May 6, 2026

Re: Case No. 17-F-0282 | All-Catt Wind Energy LLC
PETITION OF ALLE-CATT WIND ENERGY LLC FOR A SECOND AMENDMENT OF
THE CERTIFICATE OF ENVIRONMENTAL COMPATIBILITY AND PUBLIC NEED

Per your request, below please find comments in reference to the All-Catt Wind Energy LLC petition to amend its Certificate of Environmental Compatibility and Public Need (Petition), dated January 26, 2026. This letter provides supplemental comments concerning the L_{night} modeling in the March 24, 2026 PNIA for the proposed Alle-Catt Wind Farm submitted April 1, 2026 by Hankard Environmental, Inc. the day before my most recent comments were submitted April 2, 2026. The comments in this letter build on, and should be read together with, my previous comments filings of April 2, 2026, December 15, 2025, and April 22, 2025.

Figure 1

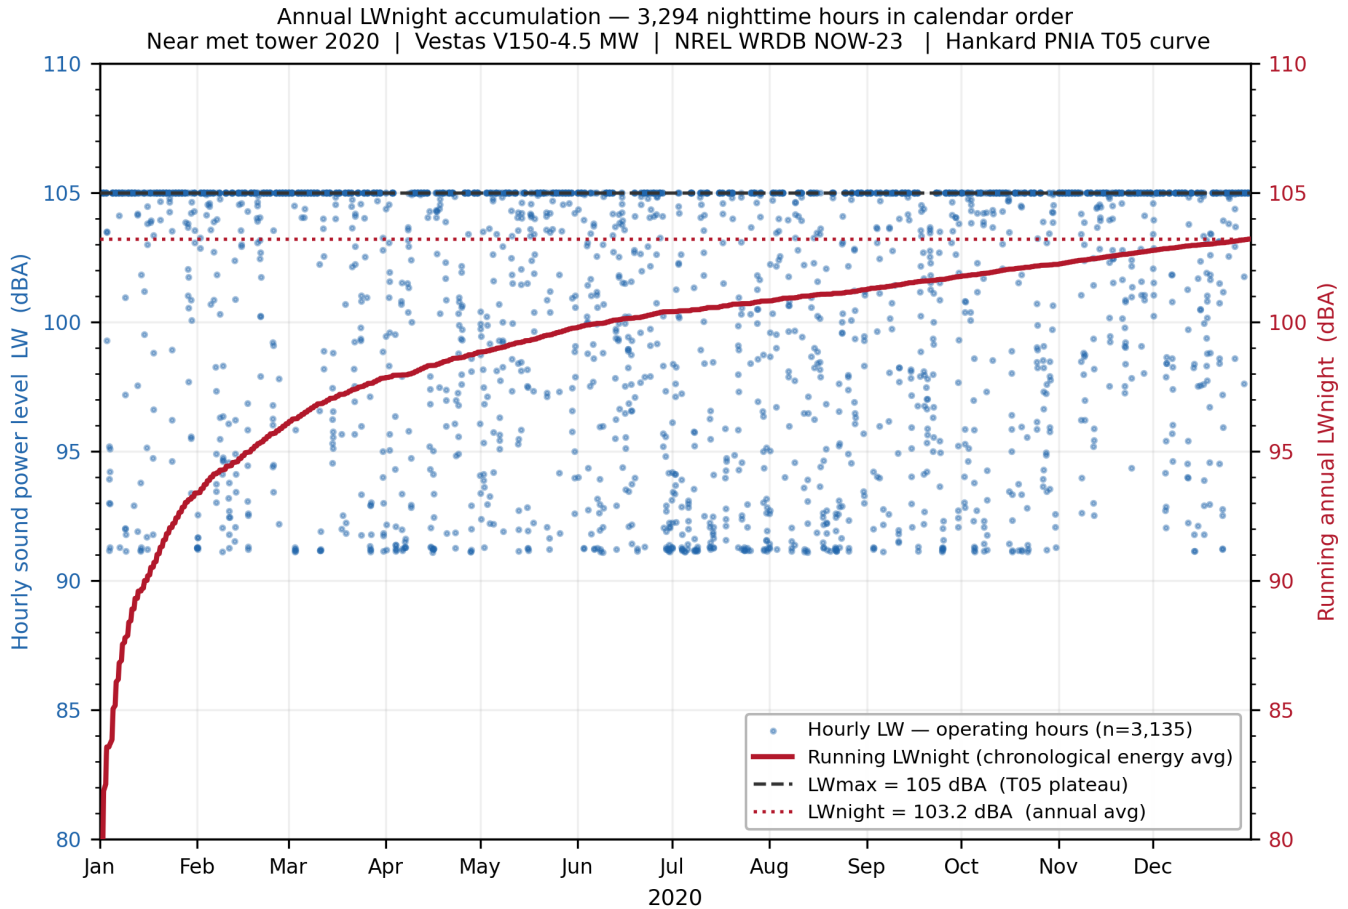
I performed an independent calculation using the WRDB NOW-23 Great Lakes wind dataset at NOW-23 grid point 304763 near the project meteorological tower, the same dataset used in my prior filings. Full-year 2020 data, 100 m hub-height wind as proxy for the 105 m turbine hub (a conservative approximation that underestimates hub wind under positive shear), nighttime window 22:00 to 06:00 local, cut-in $V_{100} \geq 3\text{ m/s}$, sound power assigned by linear interpolation of the March 24 PNIA Table T05 for the V150-4.5 STE, energy-averaged across all 3,294 nighttime hours of 2020 with non-operating hours contributing zero acoustic energy. The result is **LWnight = 103.2 dBA**, with **LWmax = 105.0 dBA**. The source-side

delta is **LWmax – LWnight = 1.8 dB**. Figure 1 presents the cumulative LWnight accumulating in chronological order across the year.

Figure 2

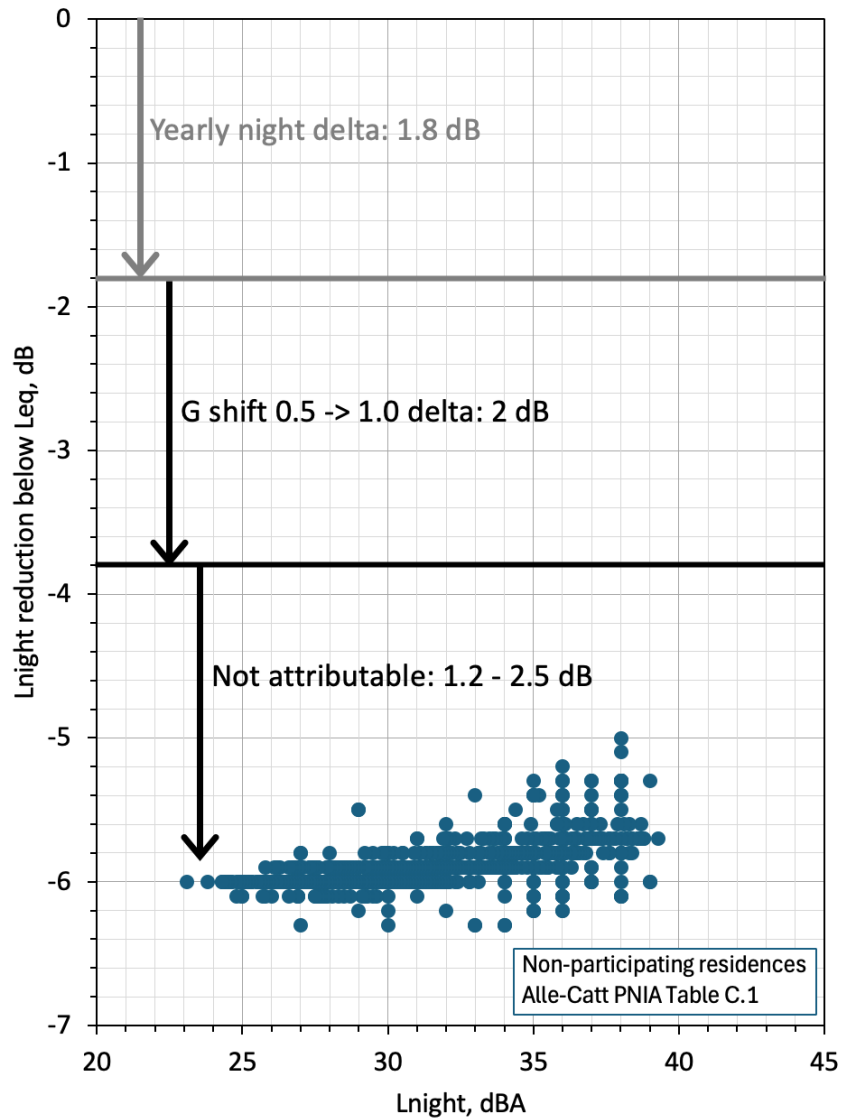
Figure 2 presents the Table C.1 receptor-level results relative to Leq and integrates the Lnight reduction with the contributions identified in this and prior comments filings: the verified 1.8 dB source-side delta (Section 4 above), the 2 dB propagation contribution from the disclosed G = 0.5 to G = 1.0 shift (controlled comparison in my prior comments), and the residual that the disclosed PNIA parameters do not account for. Substituting the verified source-side delta:

$$5.0 \text{ to } 6.3 \text{ dB} = 1.8 \text{ dB} + (D, Leq - D, Lnight)$$

$$(D, Leq - D, Lnight) \approx 3.2 \text{ to } 4.5 \text{ dB}$$

The shift from $G = 0.5$ to $G = 1.0$ contributes 2 dB as established in previous comments. A residual of approximately 1.2 to 2.5 dB at receptors is not attributable to any propagation parameter change disclosed in the PNIA narrative. The residual is comparable in magnitude to both the verified source-side delta and the disclosed G shift. Approximately one-third of the total receptor-level $Leq - L_{night}$ difference reported in Table C.1 is not attributable to any propagation parameter the PNIA discloses. A possible candidate is the meteorological correction C_{met} , which Bluestone Section 19(d) explicitly fixed at zero throughout but which the Alle-Catt March 24, 2026 PNIA Section 4.5 does not specify. A non-zero C_{met} for the L_{night} computation could account for additional attenuation and would constitute a second departure from the Bluestone procedure beyond the use of $G = 1.0$. Source spectrum differences may contribute minor additional differences. The model input data for both the Section 4.4 and Section 4.5 calculations are needed to identify the source of the residual.

1. That the Section 4.5 long-term calculation be re-run using the propagation parameter set approved in Bluestone Section 19(d), specifically $G = 0.5$, $C_{met} = 0$, $T = 10\text{ }^{\circ}\text{C}$, and $RH = 70\%$, applied uniformly with the Section 4.4 calculation. The corrected L_{night} predictions will be approximately 2 dB higher at all non-participating residences than reported in the PNIA.
2. That the model input files for the Section 4.4 and Section 4.5 calculations be made available, including the estimated L_{Wnight} , so the source of the residual 1.2 to 2.5 dB can be identified. If additional undisclosed parameter changes are present, the corrected L_{night} predictions will be higher still.
